Vermont Agency of Transportation
RECEIVED
CK'D BY RKJW OK'D BY RY
February 12, 2015
RESUBMIT No Approved AsNoted
BY RY DATE 02/12/2015

TOWN OF FAIRFIELD
SOUTH ROAD, FAS 0281 (RURAL MAJOR COLLECTOR)
BRIDGE NO.: 14 PROJECT NO.: BRF 0281(25)

PRESTRESSED SOLID SLAB DETAILS
DWG. NO: SSI

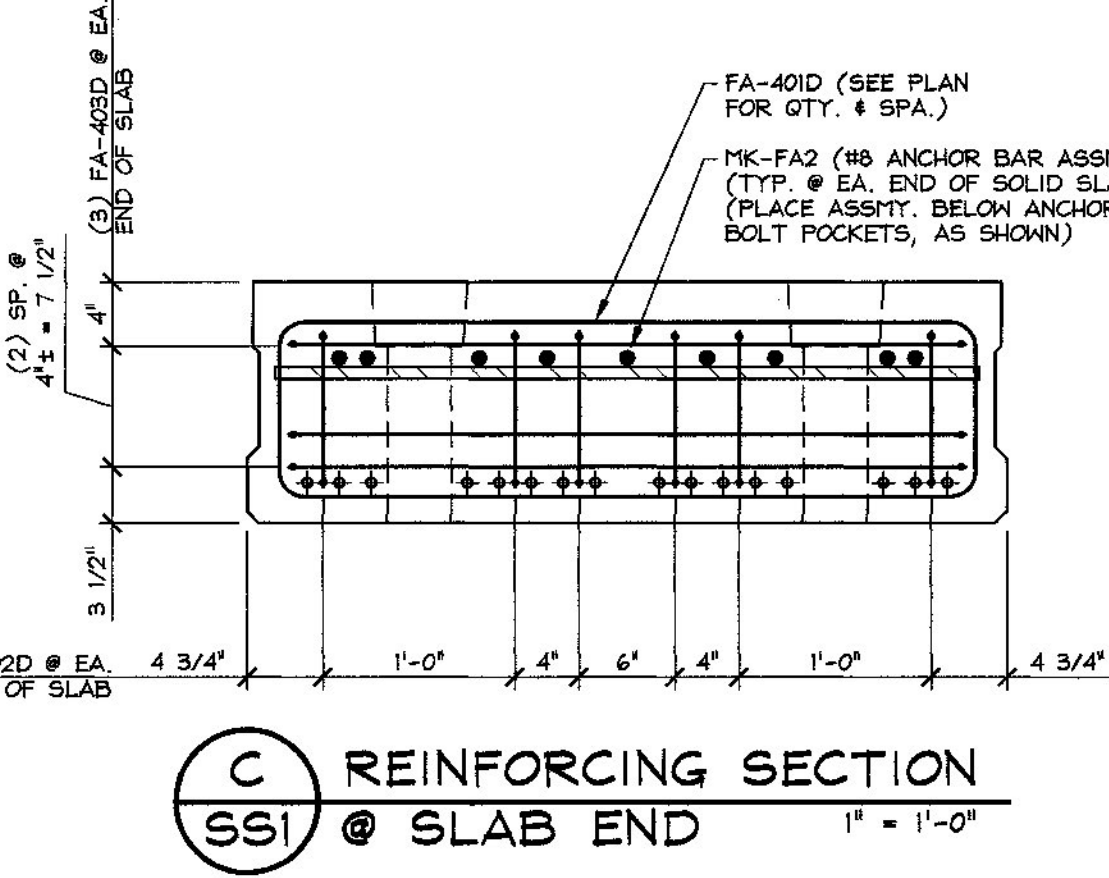
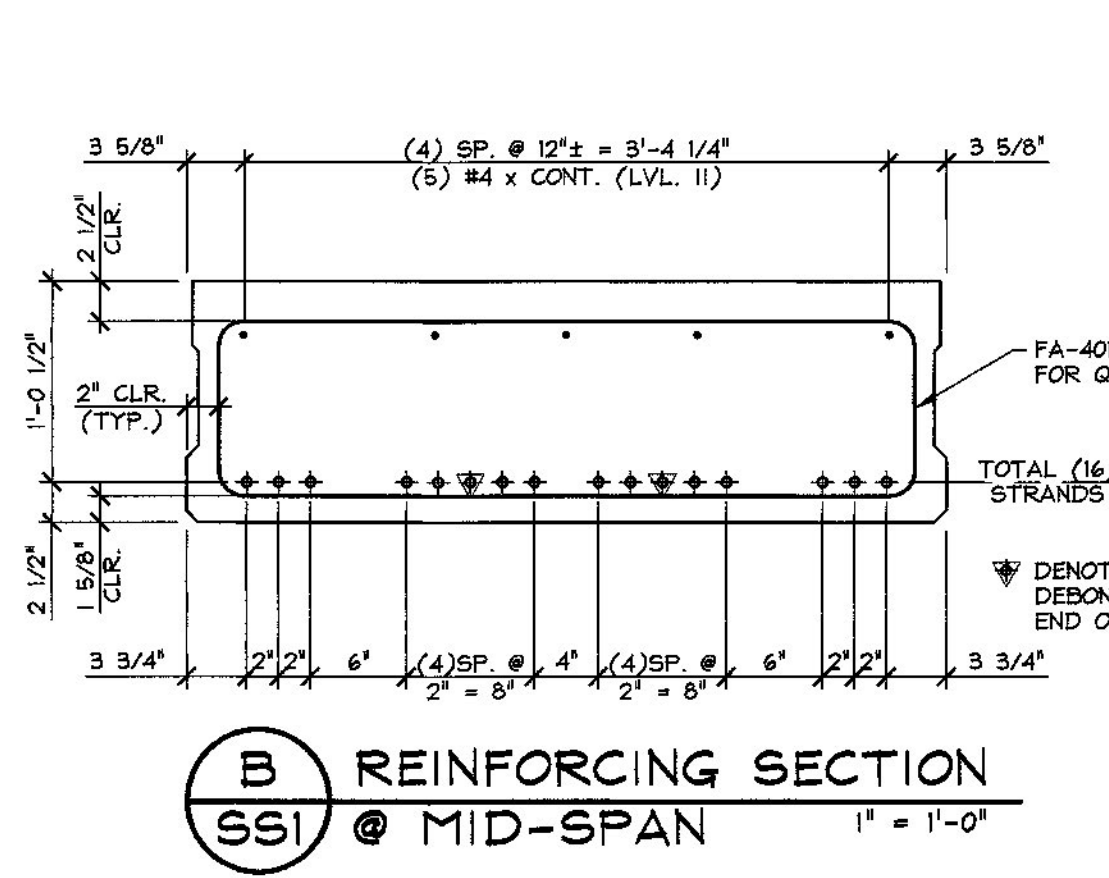
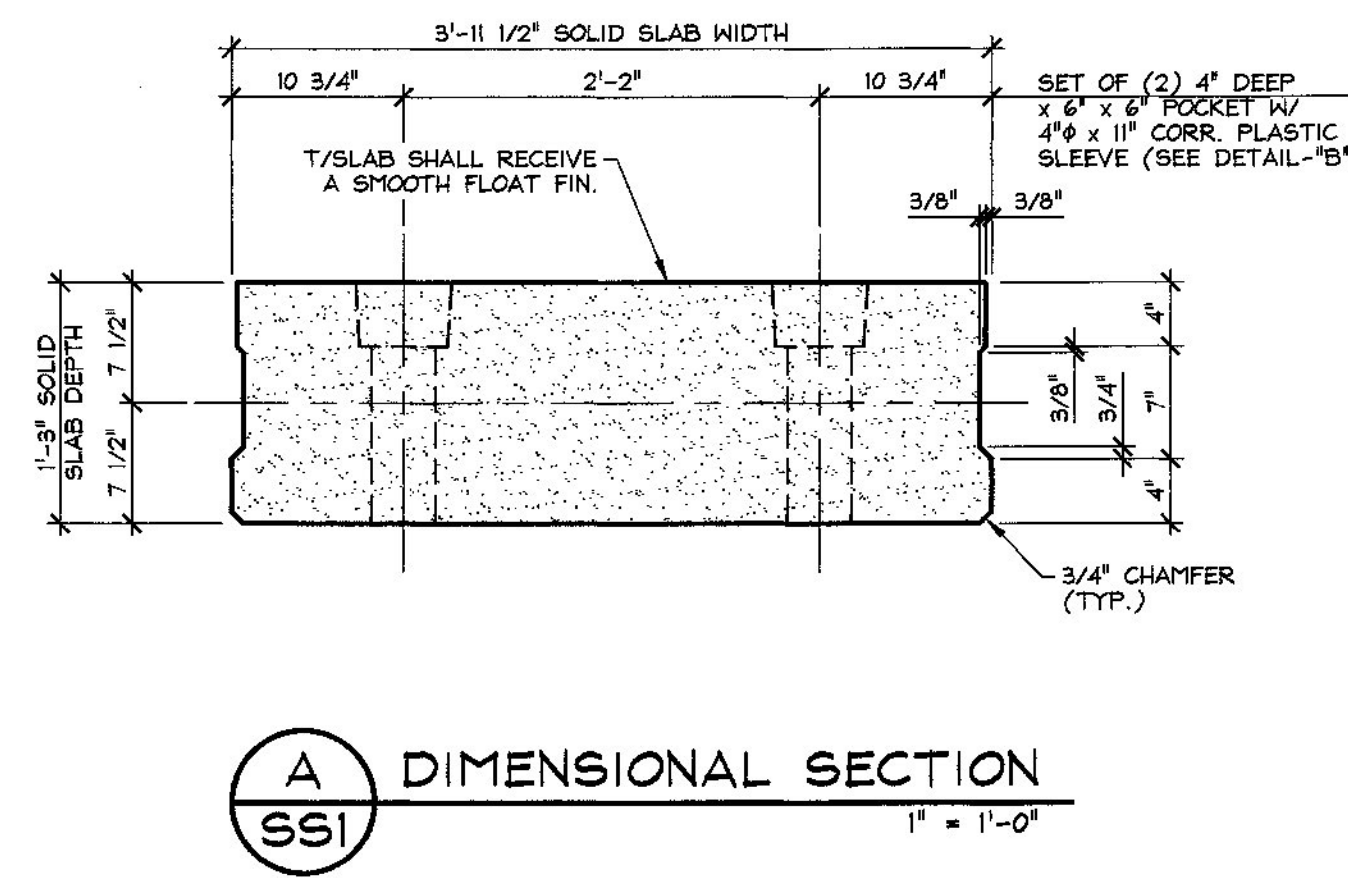
2-10-15 REVISED PER VT AOT COMMENTS
